Draft decision and reasons on Transpower's Upper South Island Reliability Stage 1 Major Capex Proposal

Draft decision and reasons paper

Date: 13 December 2012

Figure D1: Upper South Island demand forecast

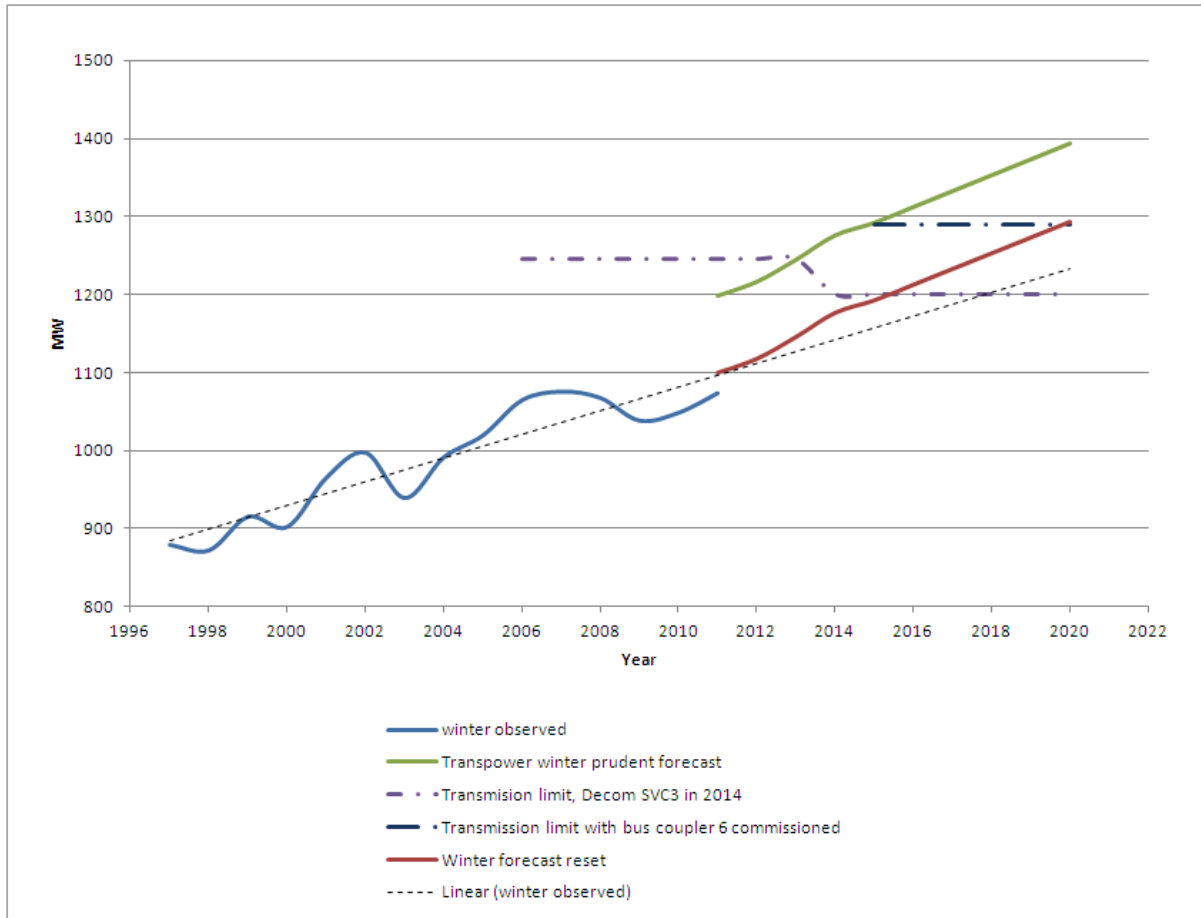
- D9 We consider that Transpower's demand forecast is optimistic because it does not allow for the decrease in demand due to the Christchurch earthquakes. Transpower has recognised this and advised us that it will monitor demand and plan investments in the USI reliability development programme accordingly. Transpower's approach seems reasonable and we consider that Transpower should be able to demonstrate that the timing for any preliminary works associated with the USI reliability development programme is optimal and takes into account all relevant factors.

- D14 Figure D1 shows our analysis of the demand forecast. The observed demand for 2011 is about 120 MW lower than Transpower's forecast demand ('Transpower winter prudent forecast' in Figure D1), indicating that demand forecast is over estimated by 120 MW. To get a more realistic demand forecast based on current observed demand, we reset the 'Transpower winter prudent forecast curve' to the 'winter observed trend line'. This line represents the linear trend of the currently observed demand. The reset curve, referred to as 'Winter forecast reset' in Figure D1, shows that peak demand may not reach the 'transmission limit with bus coupler 6 commissioned' until about 2020.⁷⁵
